1972 Corvette: Service News: Front Fender Skirt Availability

Subject: Corvette Service Fender Skirt
Model and Year: 1972 Corvette
Source: Chevrolet Service News
Page Number: 2
Date: September 1974, Volume 46, Issue #9

Fig. 2—Corvette Fender Rework

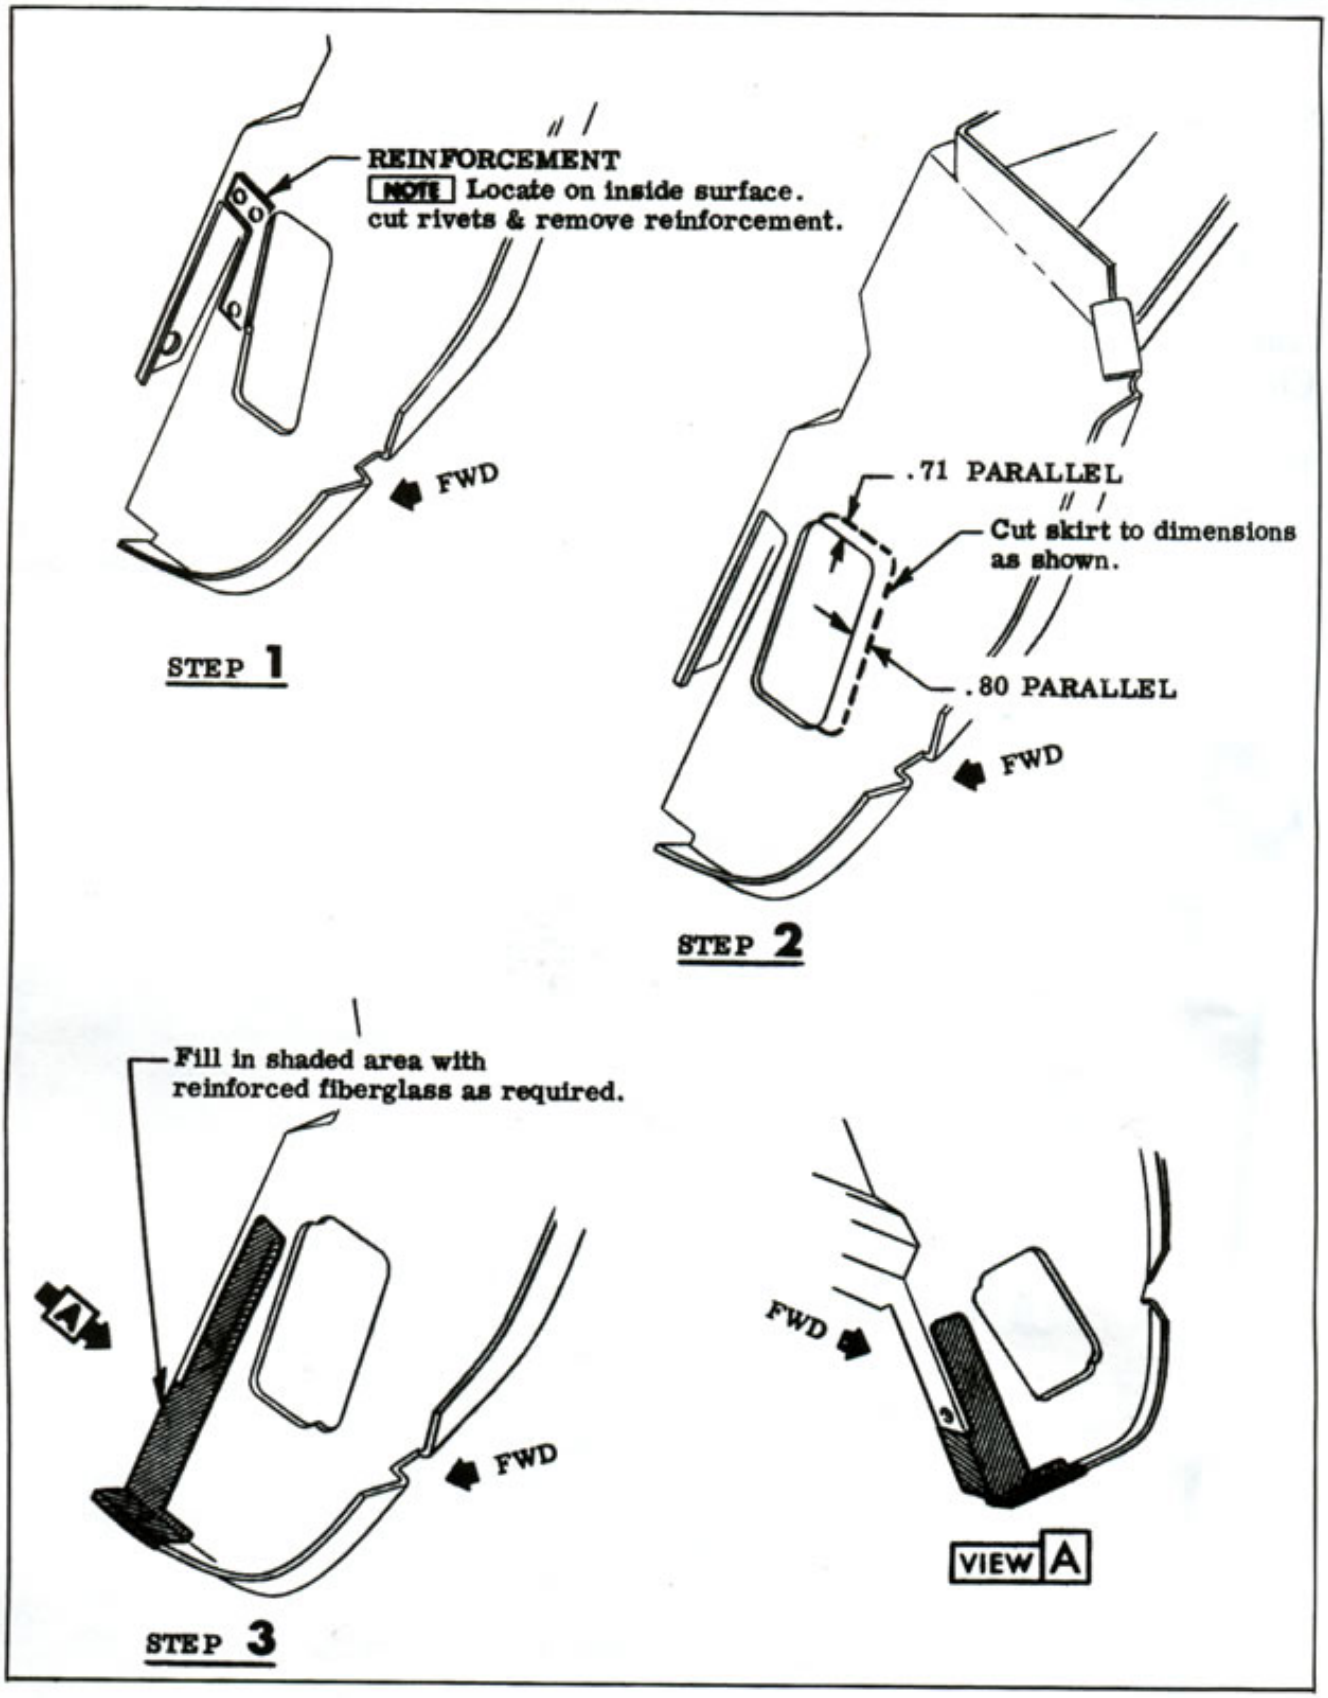
The 1972 Corvette Front Fender Skirts 6263509 L.H. and 3953054 R.H. are being cancelled and will be serviced by the 1973 Fender Skirts 331857 L.H. and 331858 R.H. This is being done because the tools have been reworked to make the 1973 skirt.

When using the 1973 skirts in place of the 1972 skirts, it will be necessary to remove and the steel reinforcement part number 334747-8 and add a material patch to provide a mounting surface for the radiator lower grille. See Fig. 2 for additional information.
